Amendments to the Drawings:

REMARKS/ARGUMENTS

FIG 1A & FIG 1B

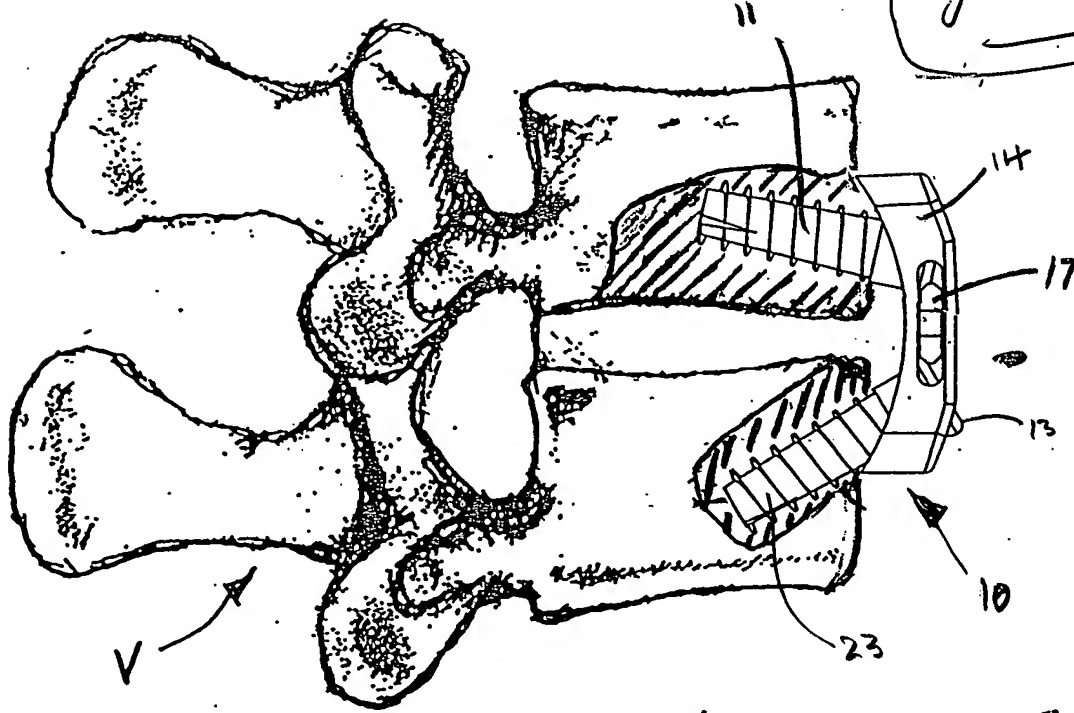
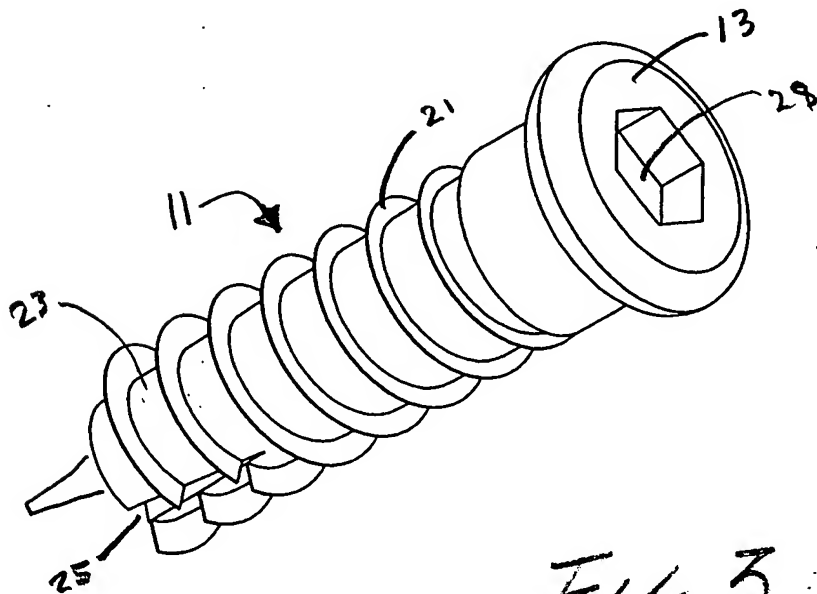
The attached sheet of drawings includes changes to Fig. 1. This sheet, which includes Fig. 1A-1B, replaces the original sheet. Figure 1A shows the plate in the correct orientation to the vertebra. Figure 1B has been added showing the plate in the orientation originally depicted in Figure 1, without a pictorial of the vertebra.

FIG. 2.

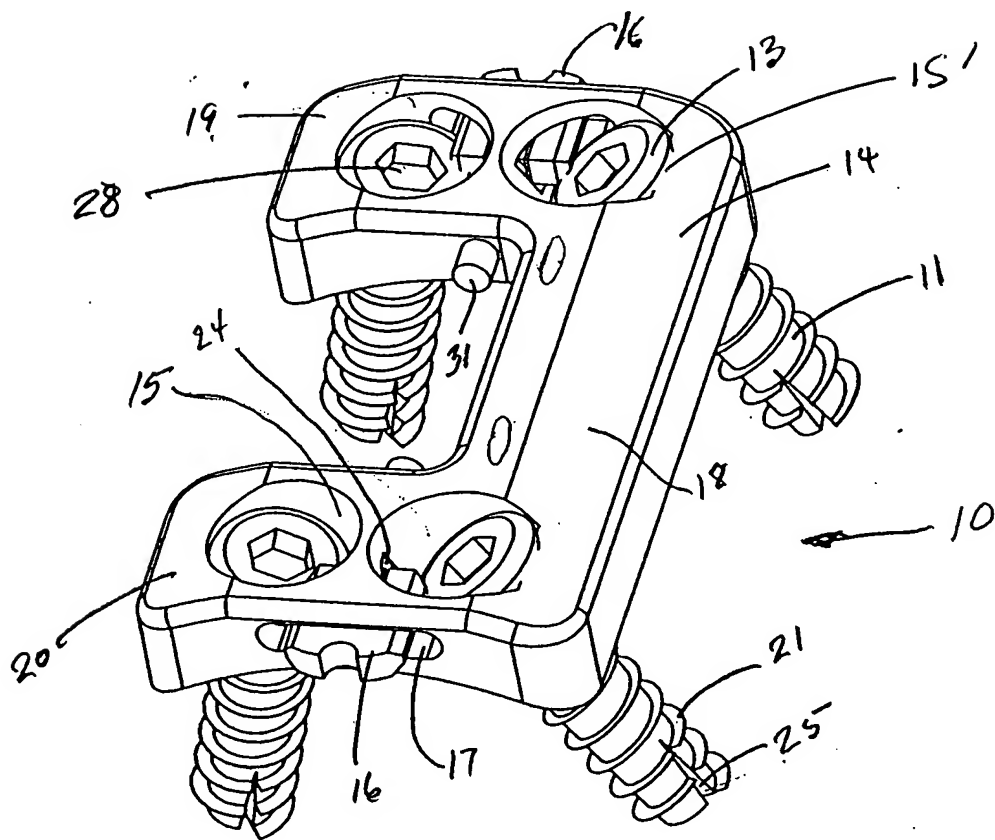
Figure 2 includes previously omitted element reference number 15' illustrating the location of the countersunk screw holes stated on page 5, line 19 of the specification.

Fig 5

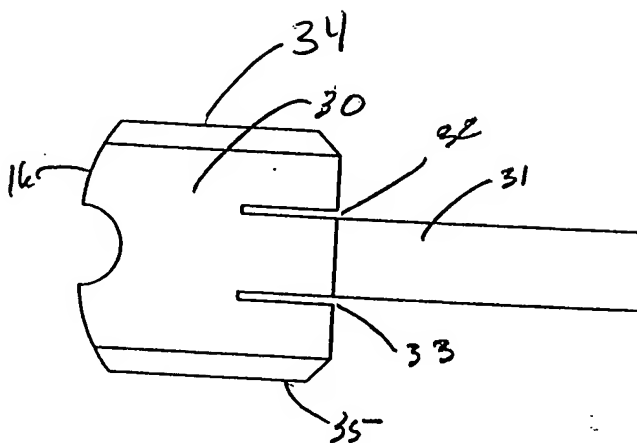
Figure 5 includes previously omitted element reference number 34 illustrating the location of the thinned edge stated on page 7, line 7.
